U.S. NUCLEAR REGULATORY COMMISSION  
REGION I

Report No. 50-293/84-14

Facility Name: Pilgrim Nuclear Power Station

Inspection Summary:

"A" RHR Heat Exchanger Outlet Valve, 1001-17A

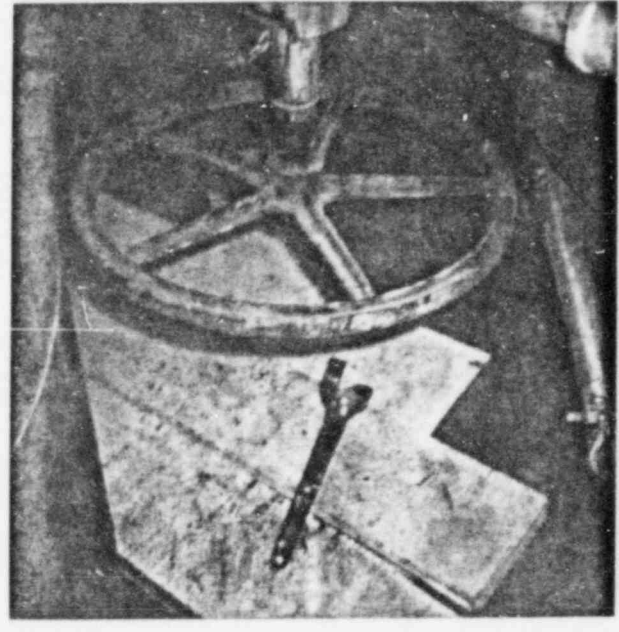
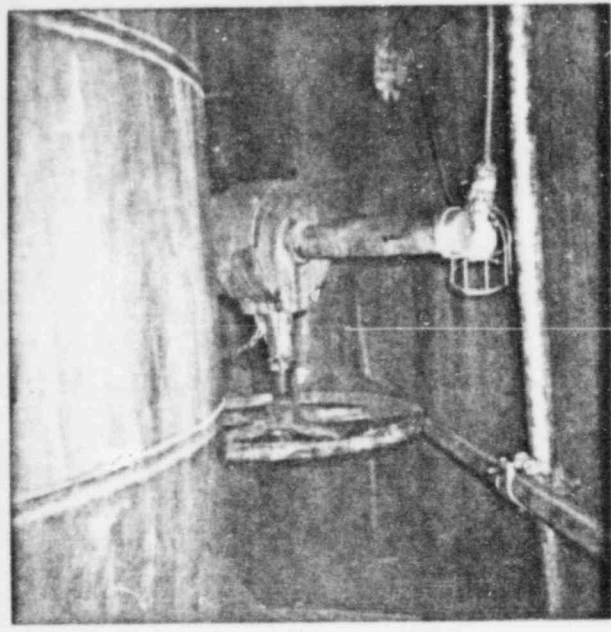
<u>Parameter</u>	<u>May 4 Survey</u>	<u>May 7 Survey</u>
Airborne Activity	1.7% MPC (1.49 E-10 uCi/ml)	30% MPC (3.22 E-9 uCi/ml)
Airborne Posting	No	Yes
Surface Contamination	150,000 dpm/100 cm <sup>2</sup> (in vicinity of valve 1001-17A)	180 mrad/hr/100 cm <sup>2</sup> , <sup>B</sup> 8 mr/hr/100 cm <sup>2</sup> , <sup>X</sup> (on valve 1001-17A)

While performing the surveillance tour of the A-RHR quad, the operator manipulated the RHR heat exchanger outlet valve (No. 1001-17A).
